18385A2

Service Manual

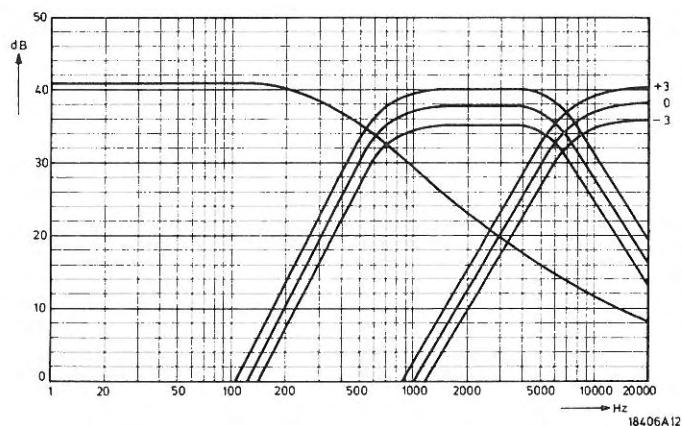
As from PL01032... resistor 802, 3E9 Ω - 7 W, codenumber 4822 113 80182, has been changed to 2E2 Ω - 7 W, codenumber 4822 113 80266.

Resistor 803, 3E3 Ω , codenumber 4822 110 23041 has been changed to 1E5 Ω , codenumber 4822 110 43032.
